ARCHITECTURAL CONTROL COMMITTEE

- A. Review plans for the construction of a single-family dwelling on Lot 7, Block 4, Sandy Bay Highland Subdivision No. 2, submitted by Zachary and Minda Peterson (property owners) and Radue Homes Inc. (contractor)

**ARCHITECTURAL CONTROL COMMITTEE
SANDY BAY HIGHLANDS SUBDIVISION NO. 2**

PLAN REVIEW CHECKLIST

Site Plan

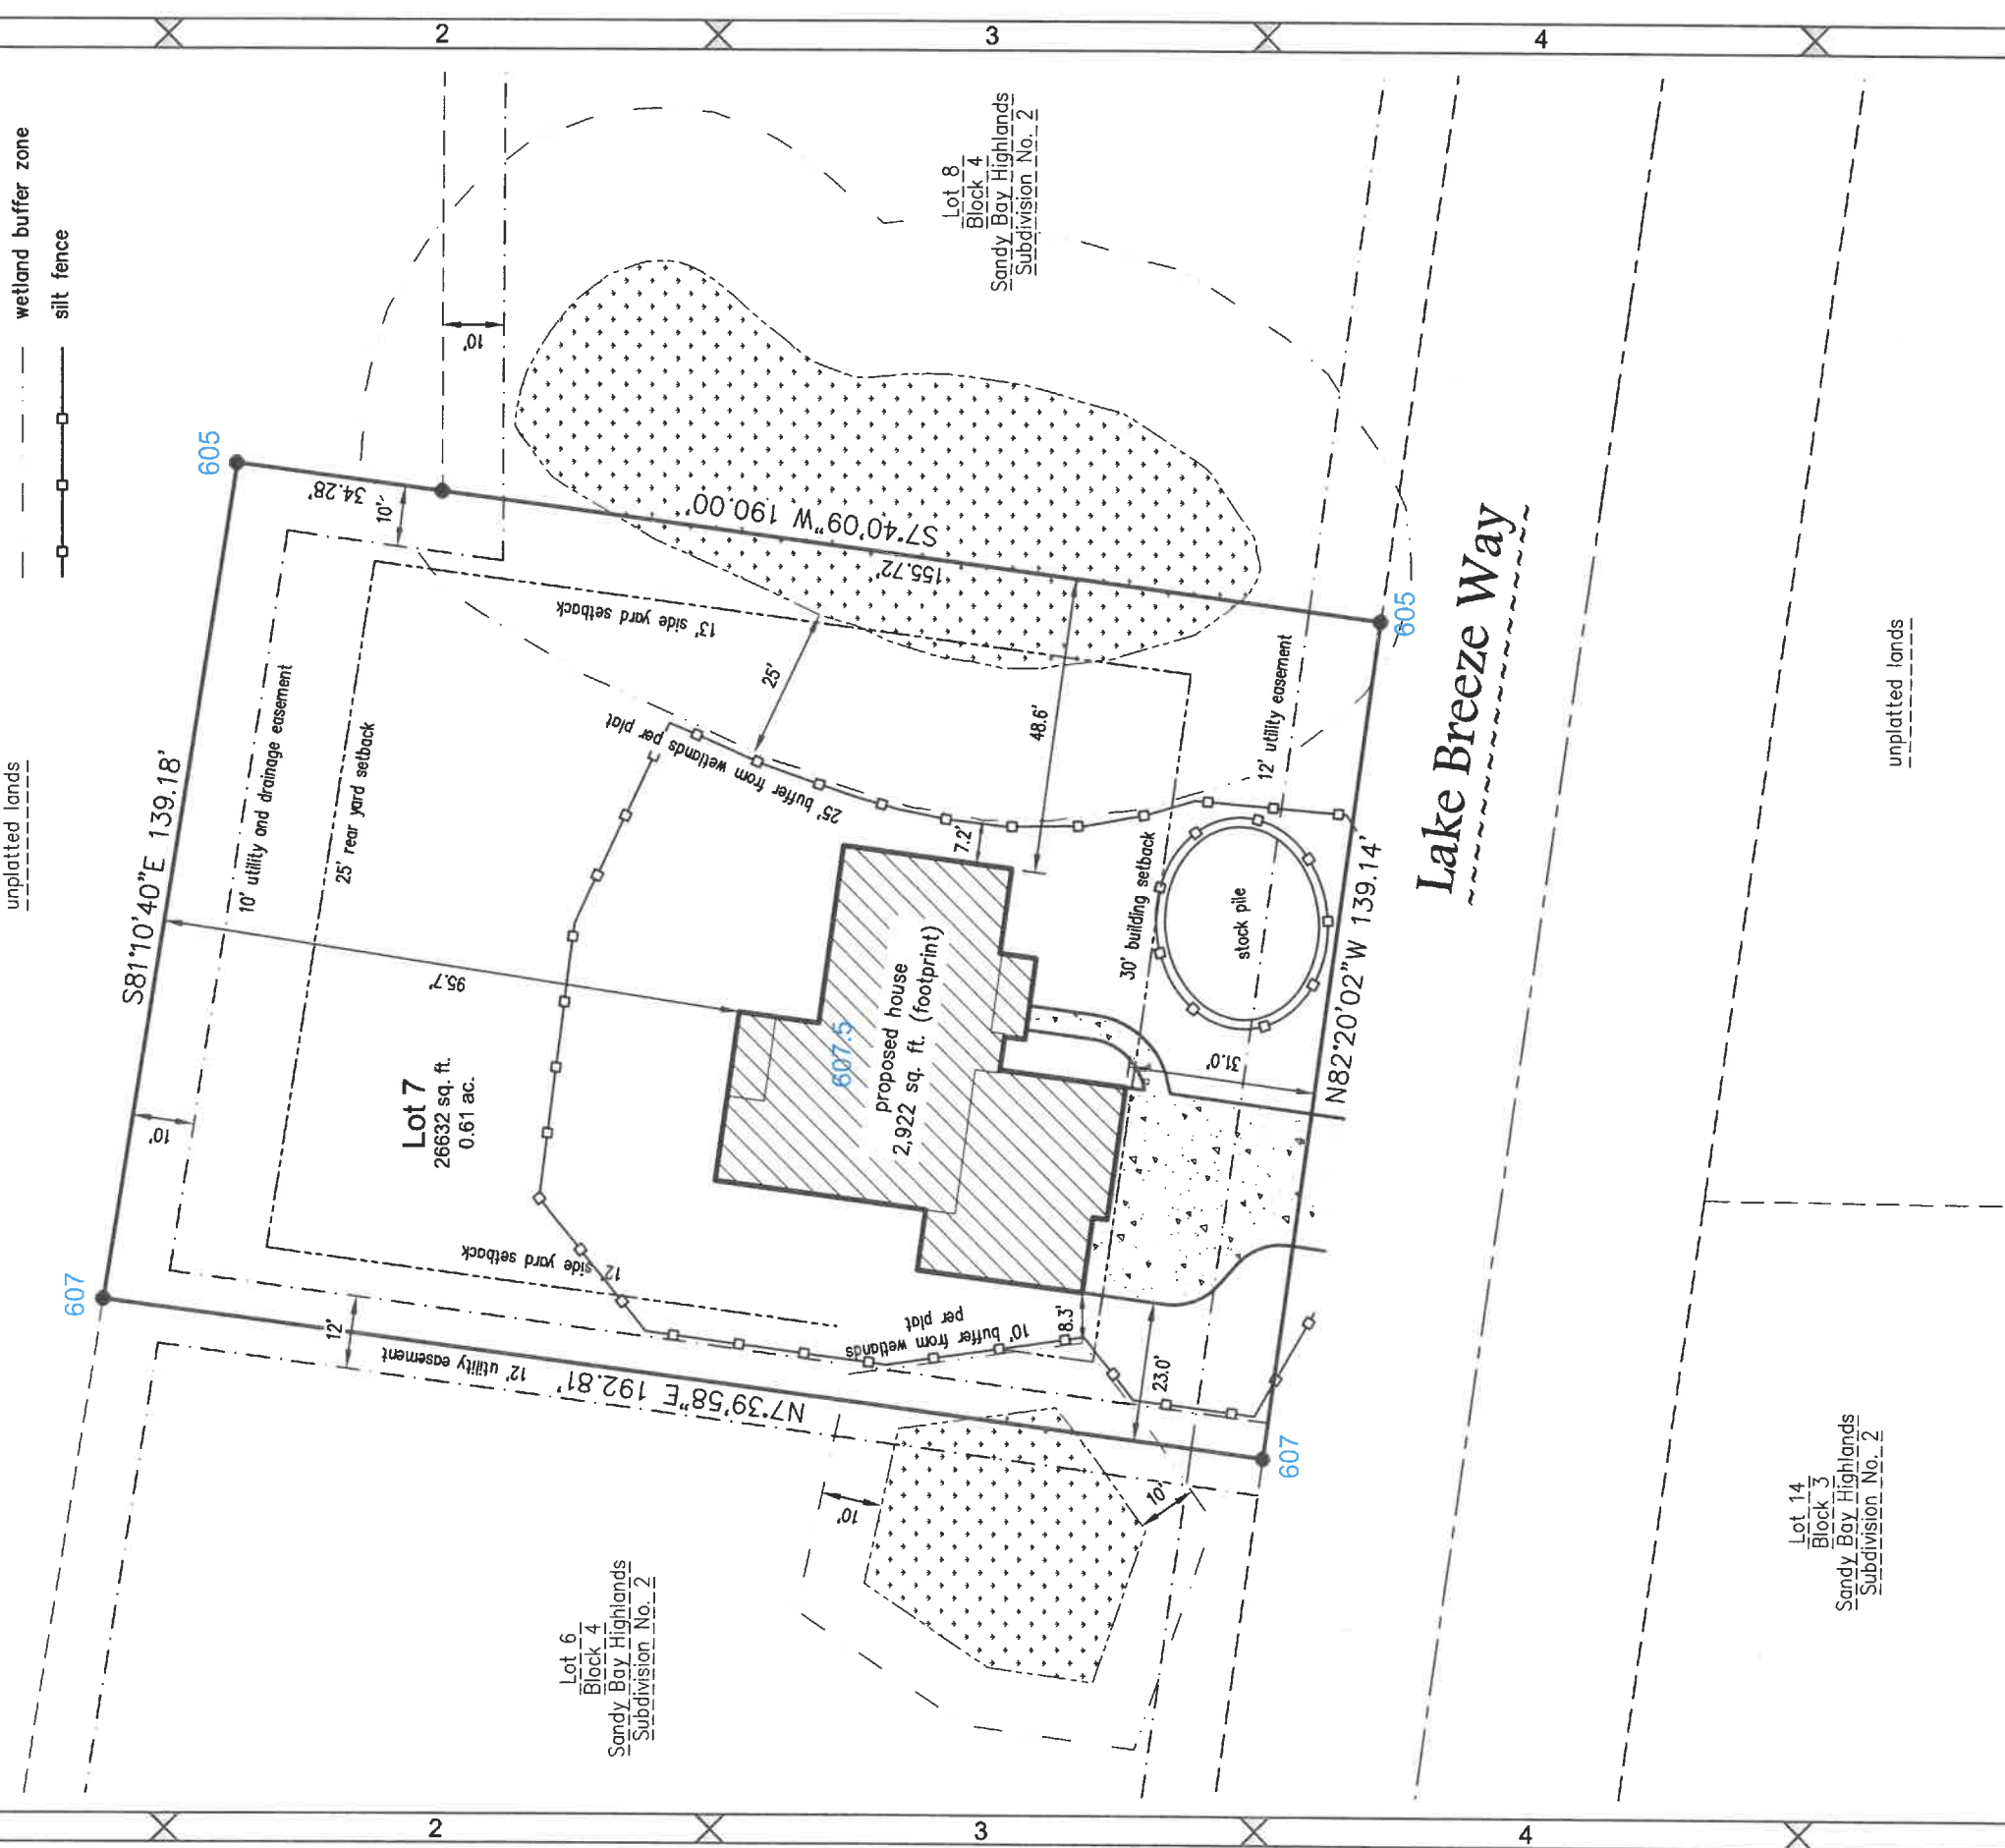
- ☒ Site Plan (to scale) *missing elevations*
- ☒ Grading Plan (to scale)
- ☒ Elevations (4 elevations - color schematic)
- ☒ Floor Plan (including sq ft for each level of dwelling)

Sump Pump must connect to public storm sewer
not shown on plan
